REVIEWER #1

In this paper, the first airborne microwave wide-band radiometer observation over Antarctica is explained. It is very well written with great results of the of the campaign. I believe this manuscript is applicable for publication in this journal after addressing few comments (some editorial).

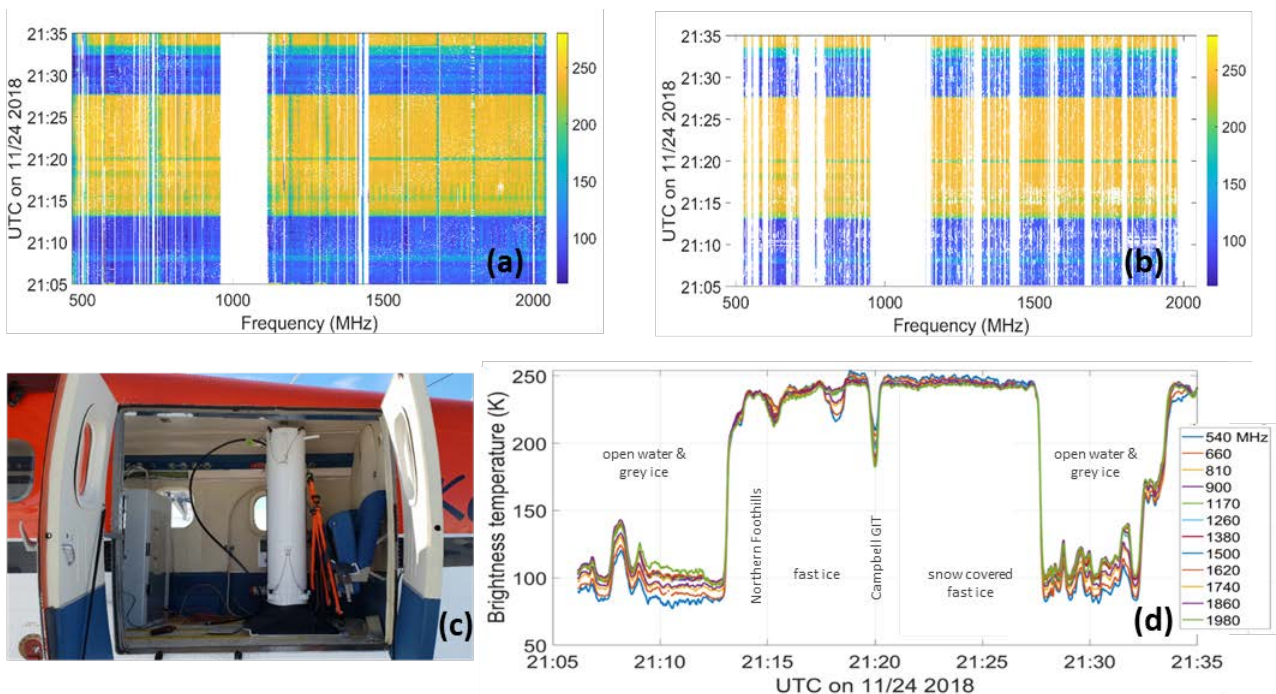
1. The two top figures in Fig. 1 are very close to each other and misleading for readers' eyes. Can you please separate them somehow? Perhaps tag the figures as a, b, c, d. Or add colorbar to the left figure, or make the box around the figure to be bolder and more distinguishable.

4. Regarding my third comment, lower right figure in Fig .1, why lower frequency of 540 MHz is the coldest before about 21:13 UTC, then it becomes hottest after that? This is opposite of the claim you had for lower frequency. Can you please explain this?

Thanks for the suggestion. The figure has been improved resulting in a higher clarity. It is reported hereinafter for your convenience.

The previous statement refers to inland ice sheets while Fig.1 illustrates, as an example, the spectral behavior over different components of the cryosphere. Over open water, all channels are cool with the lowest channels coldest because of the dielectric behavior of the water. Over thinner sea ice (as at 21:13), the low frequency are more sensitive to the radiometrically cold ocean water underlying the ice. Over the thick, low-loss glacier ice of the Campbell Glacier, the low frequencies are more sensitive to the warming thermal gradient in the ice. The figure was intended to provide the reader an idea of how the timeseries collected by UWBRAD looked when it observed different natural targets. In particular, the data before 21:13 UTC refers to open water and grey ice, which explains the low Tb values. Soon after moraine and fast ice are observed with completely different spectral features. Comment 3 refers to the inner ice sheet which was not covered in figure 1.

Thanks to your comments we recognize that figure can be improved in order to help the reader understand the general behavior of Tb. We have annotated Fig. 1 as

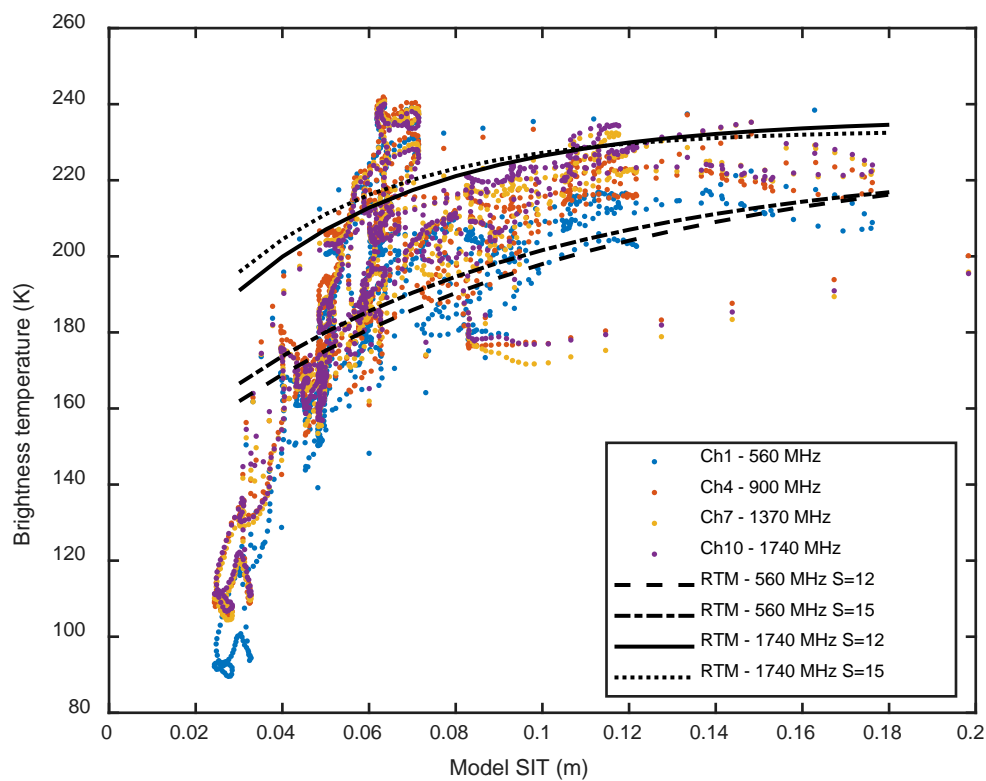
6. Please explain for the reader that why the RTM model in bottom right figure did not go less than about 4cm.

We choose to show the RTM simulations starting from 5 cm because RTM is a widely used incoherent model that assumes a single homogeneous planar slab of sea ice above water. The model breaks down when the overlying layer becomes thinner than a few cm of sea ice. More specifically, a layer thinner than a quarter of the wavelength (15 cm at 0.5 GHz and 3.5 cm at 2 GHz) cannot be treated with conventional/simple wave propagation approach and a coherent RT should

be used. As described in the text (line 297) the analysis was intended to show the potential sensitivity of UWB radiometry to SIT even for high saline shallow ice and corroborate it with electromagnetic model simulations. At line 300 we added the following sentence in order to clarify such limitation:

“RTM simulations assume a finite thickness slab of sea ice over water, and the calculation starts from a minimum thickness of 5 cm since for lower values the incoherent model fails to simulate correctly the e.m. emission. Actually, layers thinner than a quarter of the wavelength (about 15 cm at 0.5 GHz and 3.5 cm at 2 GHz) cannot be treated with conventional/simple wave propagation approach and a coherent RT should be used (which requires a highly accurate characterization of the medium surfaces seldom available in such scenarios).”

Hereinafter we report the same plots with RTM simulations starting at 3 cm but we believe that it doesn't add too much information to the paper.
